## **Response to submissions – Minto Resource Recovery Facility (SSD 7462)**

This letter responds to the items raised in the *Bingo Resource Recovery Facility, 13 Pembury Road, Minto (SSD 7462) Request for Response to Submissions*, issued on 22 August 2017 and 14 February 2018.

**RE: 13 PEMBURY ROAD, MINTO  
SWEEP PATH ANALYSIS – RESPONSE TO DEPARTMENT OF PLANNING**

## Swept Path Analysis

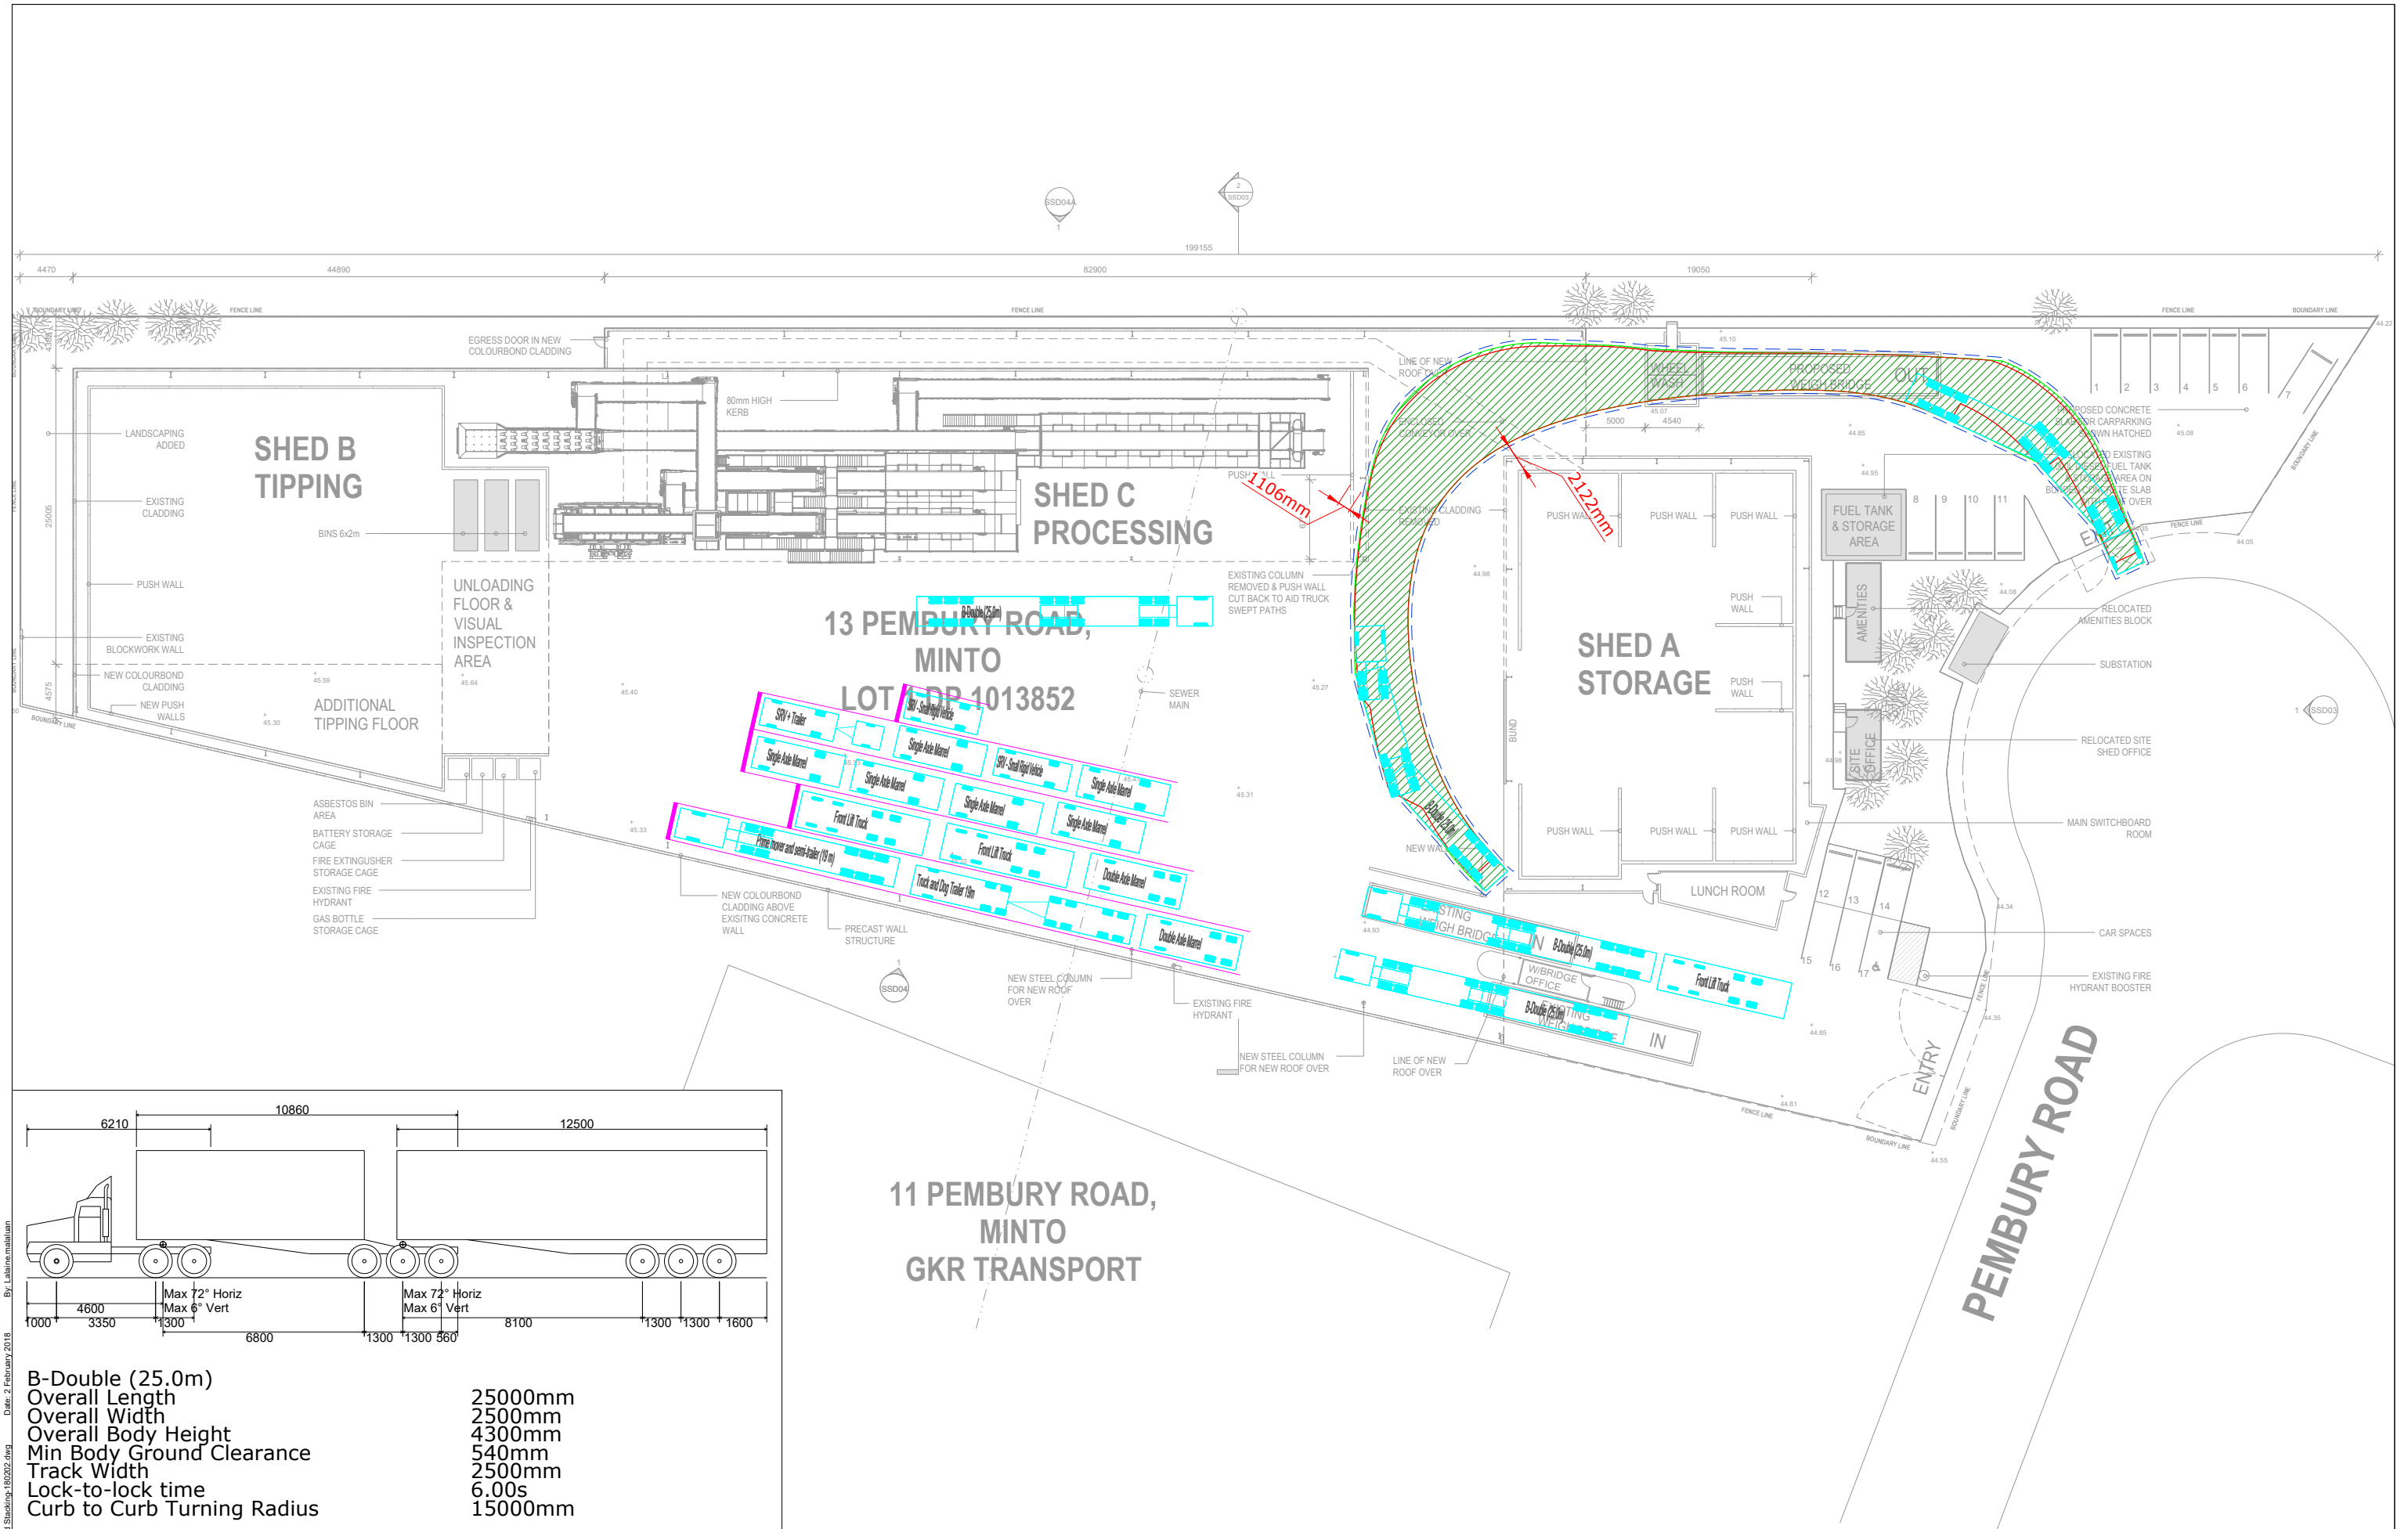
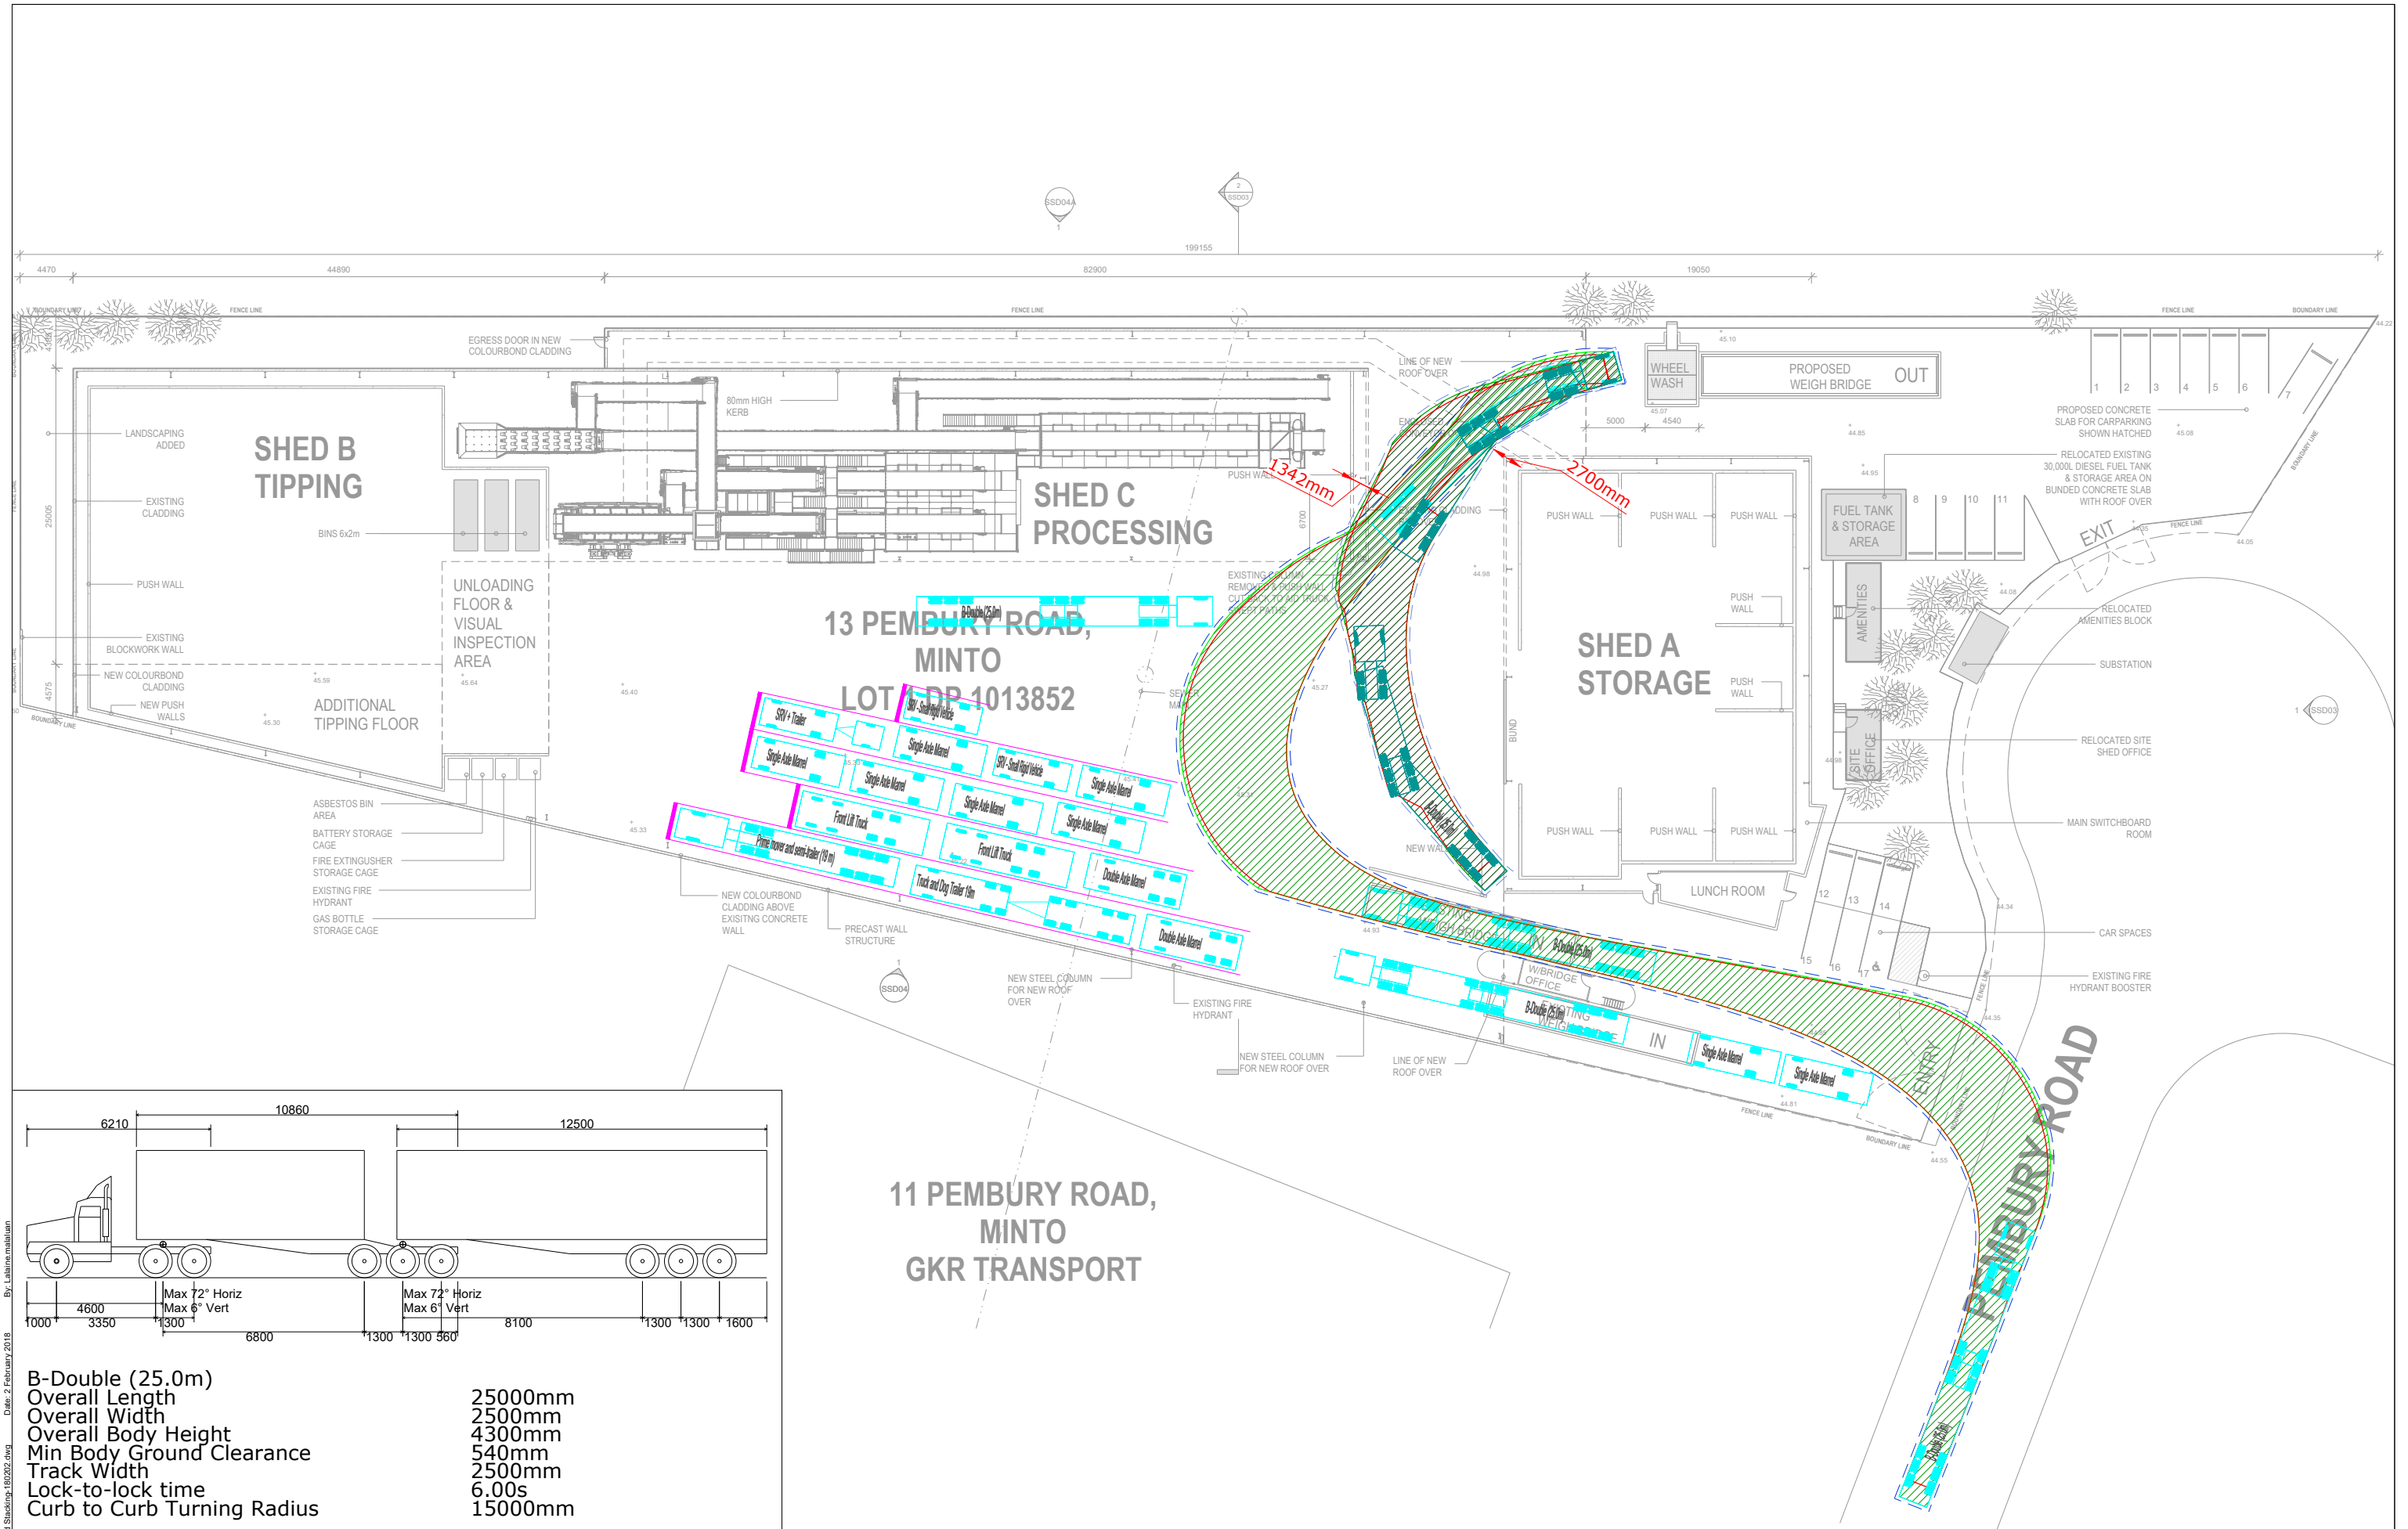
<p>At our meeting of 24 January, the Department expressed concern that the swept path diagrams for waste collection trucks will be too tight. Consideration should be given to scheduling waste collection by 25 metre trucks to outside of the early morning peak unloading period to avoid conflicts with other vehicles on-site and the</p>	<p>A technical memo has been prepared addressing this concern and demonstrating adequacy of on-site swept paths. The technical memo has been appended to this document as Attachment D.</p> <p>Following discussions between Department of Planning and Environment and the Site Operator, waste collection activities by B-double trucks will be scheduled to occur outside of the site peak operation. Waste collection by B-doubles will take place after 3:00pm and before 10:00pm each day.</p>	<p>Attachment D of this document</p>

As requested, please find herein The Transport Planning Partnership's (TPPP) response to Department of Planning and Environment's query regarding 25/26m B-double truck swept paths internal to the site located at 13 Pembury Road, Minto.

An analysis of swept paths for a 25/26m B-double truck with 15m turn radius has been undertaken using a forward manoeuvring speed of 10km/h and reverse manoeuvring speed of 5km/h. In accordance with Australian Standards, a 0.3m clearance shall be provided on both sides of a vehicle undertaking low speed manoeuvres (AS 2890.2, Clause 5.4). These clearances are shown as broken lines on the swept path plans contained in Attachment One of this letter.

In addition to the minimum required 0.3m clearance, the swept path analysis indicates that a B-double truck is able to manoeuvre on site with an additional clearance of up to 2.791m to physical obstructions. Additional clearances, on top of the standard 0.3m, are shown on the swept path plans contained in Attachment One. A summary of these extra clearances is provided in Table 1.

Swept Path Plan Reference	Description	Clearance to Shed A (Right side of Vehicle)	Clearance to Shed C (Left side of Vehicle)
Figure 1	25m B-Double Swept Path via Inbound Weighbridge (1) Inbound Movement	2.274m	1.347m
Figure 2	25m B-Double Swept Path via Inbound Weighbridge (1) Outbound Movement	2.122m	1.106m
Figure 3	25m B-Double Swept Path via Inbound Weighbridge (2) Inbound Movement	2.700m	1.342m
Figure 4	25m B-Double Swept Path via Inbound Weighbridge (2) Outbound Movement	2.122m	1.106m
Figure 5	25m B-Double Swept Path via Inbound Weighbridge (1) Inbound Movement	0.891m	1.851m
Figure 6	25m B-Double Swept Path via inbound weighbridge (1) Outbound Movement	2.791m	0.904m
Figure 7	25m B-Double Swept Path via Inbound Weighbridge (2) Inbound Movement	2.432m	1.258m
Figure 8	25m B-Double Swept Path via Inbound Weighbridge (2) Outbound Movement	2.791m	0.904m

The above summary indicates that there will be, at least, 0.891m clearance to any physical obstructions on top of the standard 0.3m clearance. This is measured on the left side of the vehicle as it reverses into position alongside Shed C.

The swept path analysis demonstrates that a B-double truck will always have a clearance equal to or greater than 1.191m (0.891m + 0.3m) measured between the vehicle body and a physical obstruction along its travel path between Shed A and Shed C.
